This page lists the known errors on the gm5x5x5 PCBs. There are no known issues with the bulk order run (white pcbs), the following information is valid **only** for the prototype run (green pcbs).

## **Bulk Order #1 (white pcb, rev 1.0)**

## **Prototype Run**

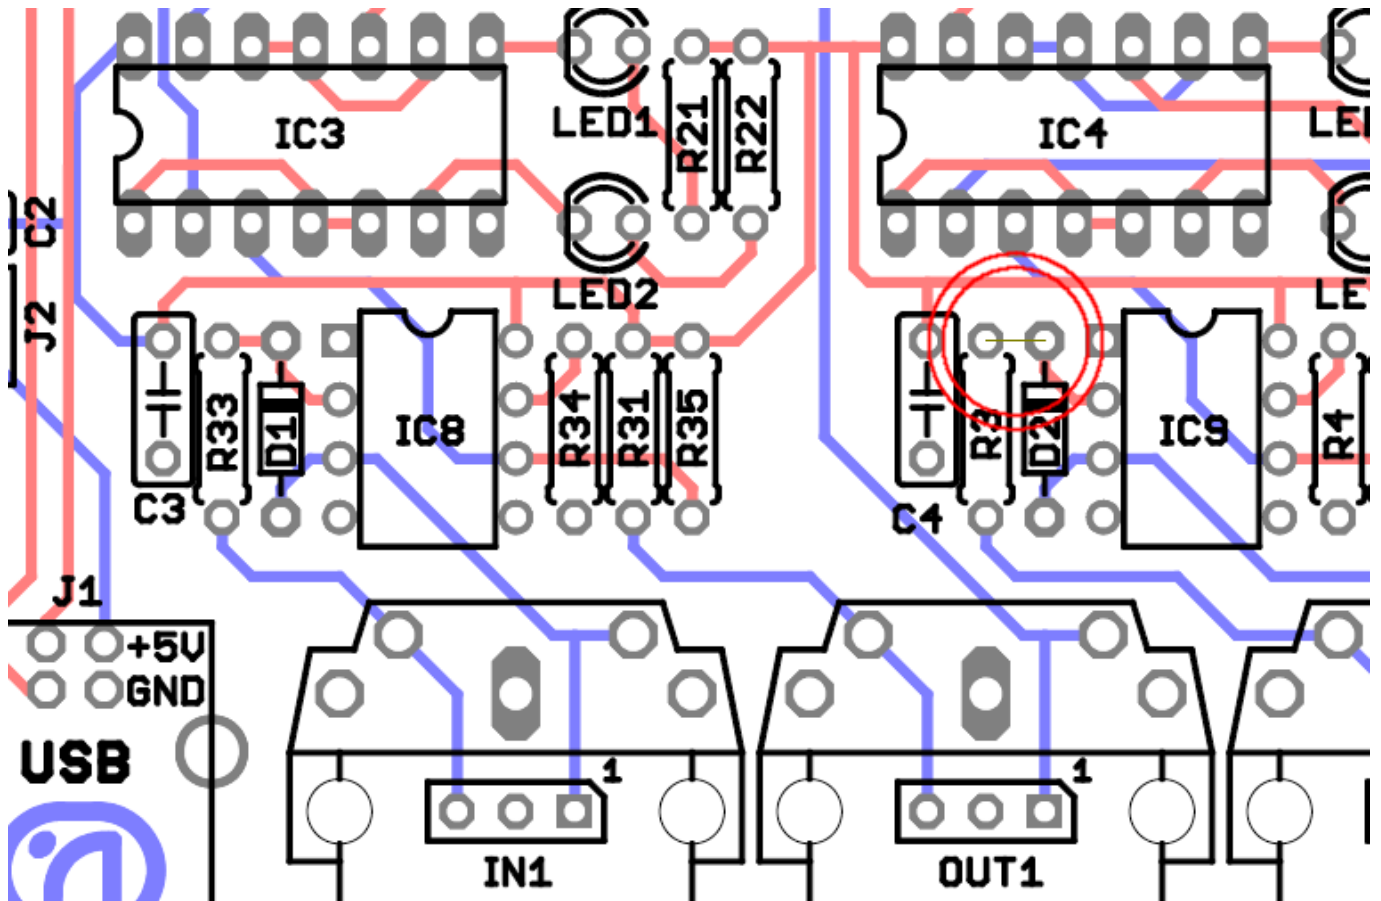
**Problem:** The MIDI IO pins of the midi sockets (Pin 4 + 5) are switched.

**Problem:** A track between D2 and R3 is missing.

**Solution:** Either (1) use the pin-headers if you use sockets that are not mounted on the pcb or (2) break the traces to pins 4 + 5 of the sockets and solder wires to them or (3) solder the midi sockets on the other side of the pcb.

**Solution:** Bridge the pins.
